Shepherds Bay Redevelopment

Modification request for Concept Plan MP 09_216 and Project Application MP09_219

Submission from City of Ryde Council

Indicative section of proposed Community Facility in Stage 9:

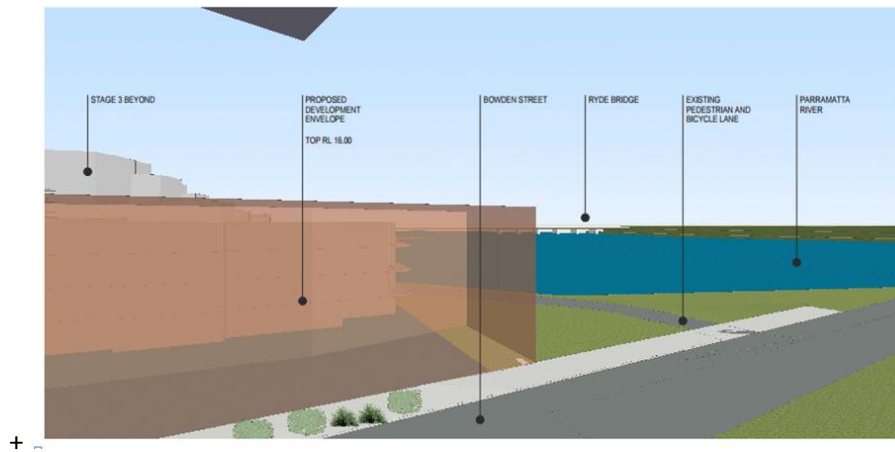
Despite applying to increase the number of dwellings the Modification application seeks to reduce the size of the community centre from 1000m² to 500m². The application seeks to place the community centre within Stage 9, located over the subterranean gas pipeline. As a result of the clearance requirements for the pipeline and the floor to ceiling requirements for a multi-purpose community hall, the overall height for this community centre building (16m+), when combined with the proximity to the adjacent apartment building and consequent impacts, cannot be supported by

Council (indicative section provided below). As a result of these concerns Council proposes that this building is restricted to 1 storey maximum. As options put forward for the community centre have proved unsatisfactory, it is suggested that conditions of consent allow Council and the Developer to continue to work together to achieve a satisfactory solution.

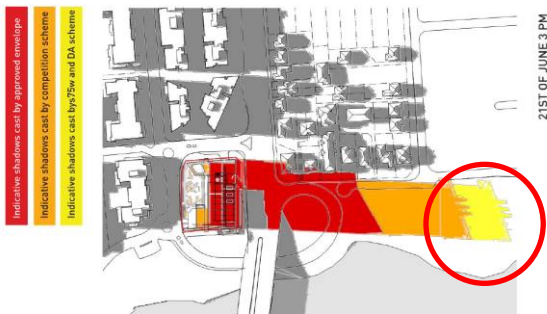
- The shadow diagrams are not correct and a complete assessment of the overshadowing impact cannot be made. However, it appears that the competition winning scheme and the further increases to the tower height will likely result in overshadowing to homes at 2-8 Waterview St from around 2.30pm onwards mid-winter. Objection is raised to this impact.

Note: The increased overshadowing is both on the public domain/sensitive foreshore and mangrove areas and probably on private homes east of Osborne Avenue at 2-8 Waterview St Putney. The shadow diagram for 3pm 21 June indicates that shadows extend appreciably east of Osborne Avenue but the diagram does not show the residential development in this area. This is illustrated in the below comparison of the proponent's shadow diagram and aerial photo. 2, 2A, 4, 6, 6A and 8 Waterview St sites are highlighted on the aerial photo.

<p>The proponents shadow diagram Dwellings east of Osborne Avenue, including 2-8 Waterview St, are not indicated in the shadow diagram. The location of these dwellings is circled in red</p>	<p>Aerial photo of the same area 2-8 Waterview St (6 dwellings) are highlighted and circled in red on the aerial photo and will likely be overshadowed from 3pm 21 June and earlier.</p>

- The shadow diagrams for 21 June need to be accurately updated in order to make a proper assessment of the impact of overshadowing as a result of the additional height. The residents of 2-8 Waterview St should have further opportunity to comment on the impacts upon the preparation of accurate shadow diagrams.
- It is noted that the competition scheme at 19 storeys is preferable in terms of overshadowing impacts to the proposed 24 storey tower.

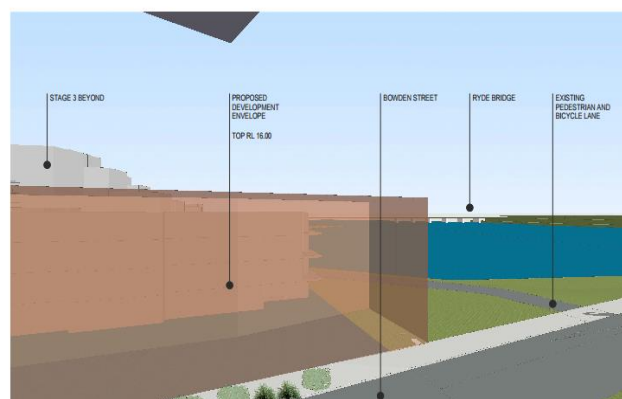
The proposed location of the community centre within stage 9 satisfies some of the abovementioned requirements. However, the proposed configuration and narrow floor plate does not support a broad range of community uses and the likely impacts on residents of 146 Bowden St cannot be supported.

- Objection is raised to the proposal to relocate the community facility to the stage 9 building on the basis of:
 - The overall height of the building will result in a negative impact on the residential apartment building under construction at 146 Bowden Street, overshadowing, views, outlook, ventilation and sunlight access.

Note: The community facility is to be approx. 8m floor to ceiling clearance to ensure flexibility for a range of uses and construction over the subterranean oil pipeline requires an 8m clearance resulting in a building over 16m tall – taller than the apartment building at 146 Bowden Street. Refer diagrams below – particularly the diagram bottom right.

Figure 1 – Parsonage Street / Well Street / Porter Street Preferred Configuration

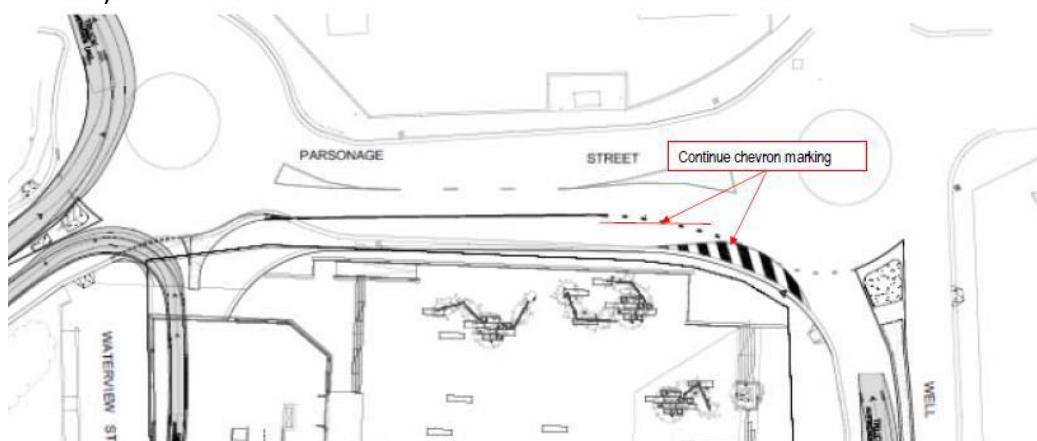
- The proposed access arrangement immediately south of the Parsonage/Well/Porter Street roundabout provides opportunities for unnecessary weaving, introducing potential operational and safety issues. It is recommended to maintain a single southbound lane

departure from this roundabout prior to developing the access left turn lane (refer to **Figure 1** below).

Figure 2

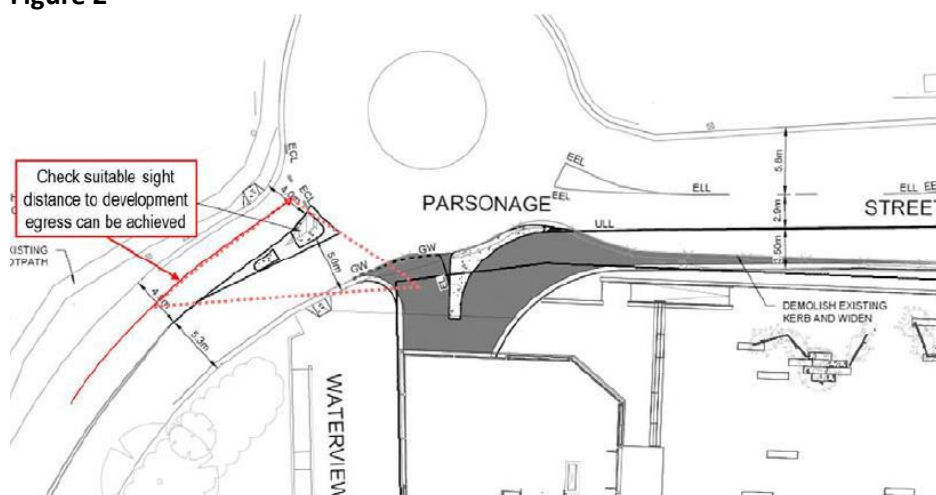
- The proposed access onto the Parsonage Street/The Loop Road roundabout introduces sight distance and turn radius concerns which require further investigation, particularly for traffic approaching from The Loop Road and their ability to observe a vehicle exiting the development's driveway (refer to **Figure 2** below).

Figure 3

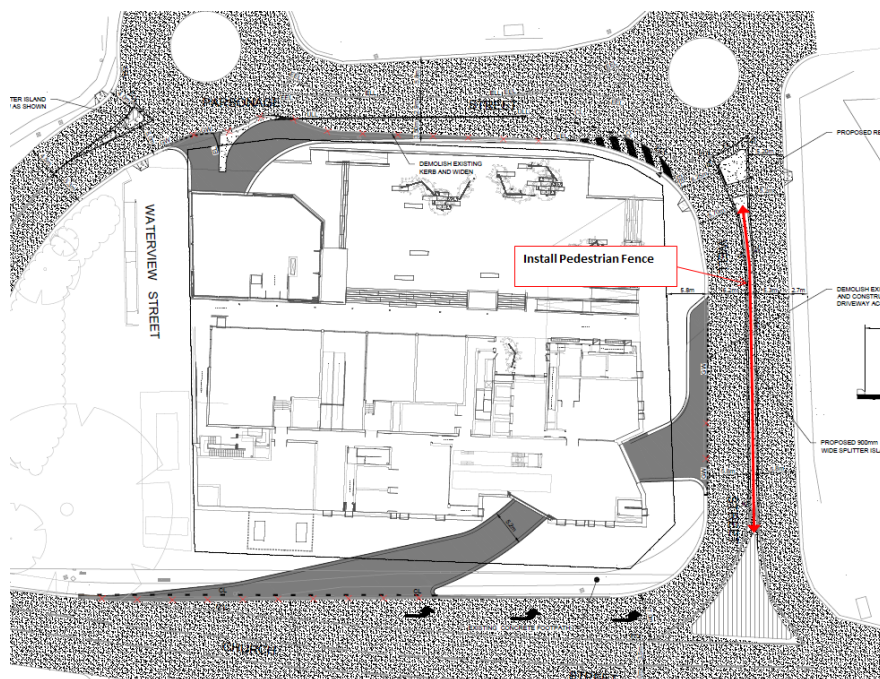
- Undertake a Stage 1 Road Safety Audit of the access intersection configuration/ existing roundabouts.
- It is noted that 900mm wide splitter island in Well Street will be extended to the pedestrian refuge. It is recommended that the pedestrian fence be installed to prevent pedestrians from walking across Well Street and to encourage using the proposed pedestrian refuge (refer to Figure 3 below). It is recommended that the provision of these works be conditioned in any consent.
